SERVICE BULLETIN

FRONT BRAKE DISC MOUNTING NUT CHANGE

CB-350F FRAME SERIAL NUMBERS
1000001 THROUGH 1070099

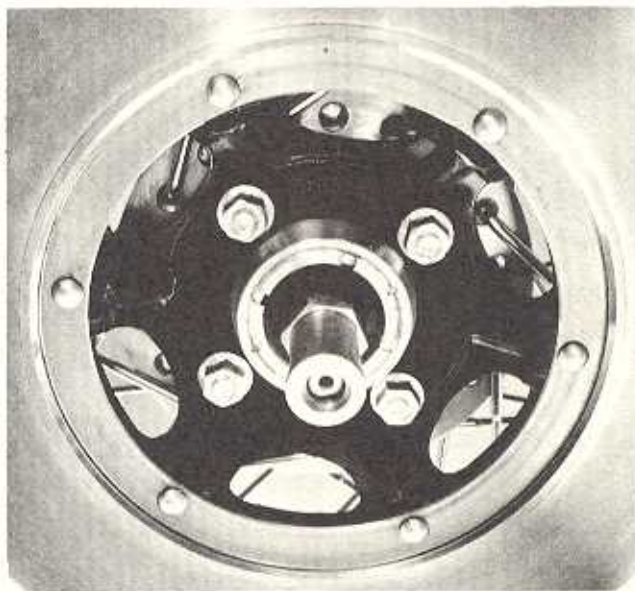
Standard nuts and tongued washers secure the front brake disc.

Nut: P/N 94001-08000-OS.

Tightening torque:

180 - 230 kg-cm
(13.0 - 16.6 lb. ft.)

CAUTION: Install new tongued washers after removing nuts. Do not reuse tongued washers.

CB-350F FRAME SERIAL NUMBERS
1070100 AND SUBSEQUENT

UBS nuts secure the front brake disc. Tongued washers are not used.

UBS Nut: P/N 90309-357-000

Tightening torque:

270 - 330 kg-cm
(19.5 - 23.9 lb. ft.)
